City of Hamilton - Heritage Permit Application Note Sheet

Address: 122 McNab Street South, Hamilton (MacNab-Charles Heritage Conservation District, Part V)

Permit Number: HP2025-023

Figure 2: Photo of rear southwest parapet requiring repair

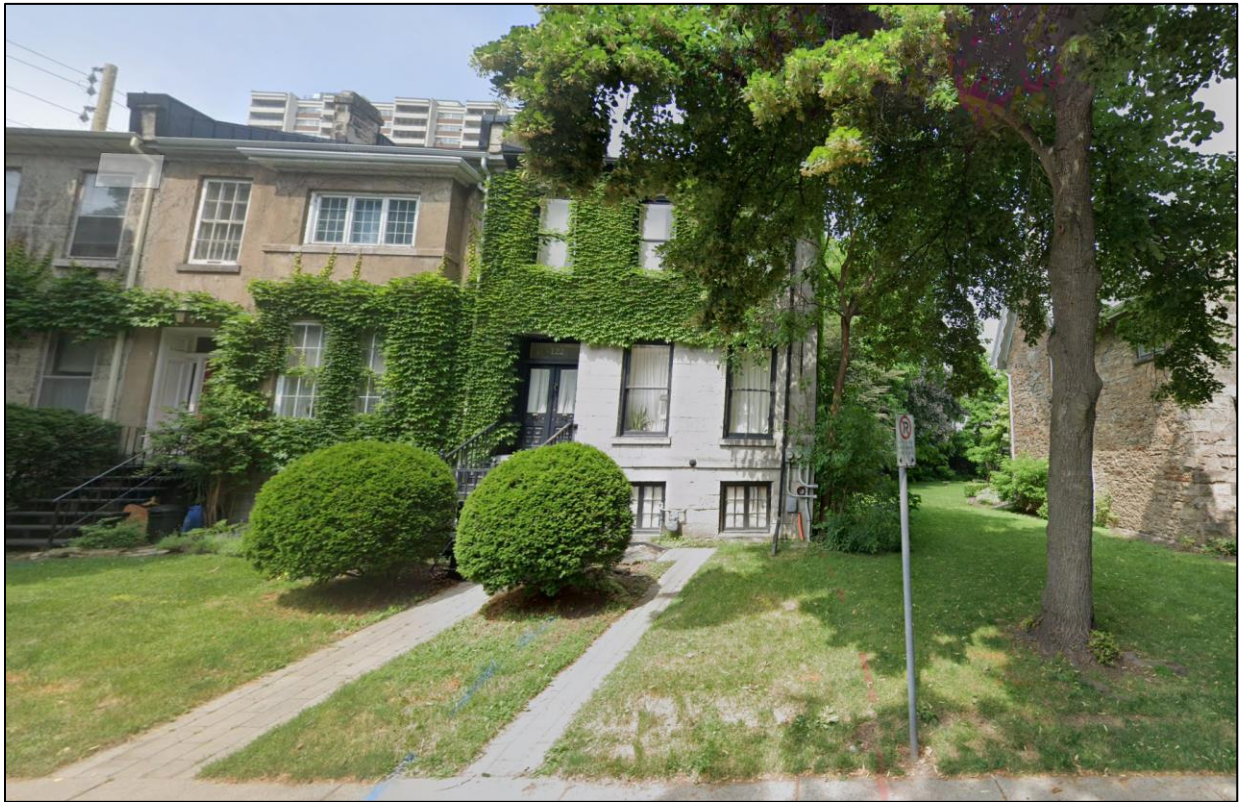
- Restoration of the brick parapet on the south-west corner of the rear wing of the building, including:
 - Repointing with a 1-1-6 course cream line mortar with pigment to match; and,
 - Installing true pressed clay bricks (lbstock) to replace missing or damaged bricks, to match the existing bricks.
-

- Parapet is in poor condition, with brick that needs to be re-mortared or replaced.
 - Work is required for the property to comply with an order issued under the City's Property Standards By-law.
-

- ☐ That the proposed masonry repairs be conducted in accordance with the City's Masonry Restoration Guidelines and that the mortar repointing specifications be submitted, to the satisfaction and approval of the Director of Planning and Chief Planner, prior to commencement of any alterations;
- ☐ That any minor changes to the plans and elevations following approval shall be submitted, to the satisfaction and approval of the Director of Planning and Chief Planner;
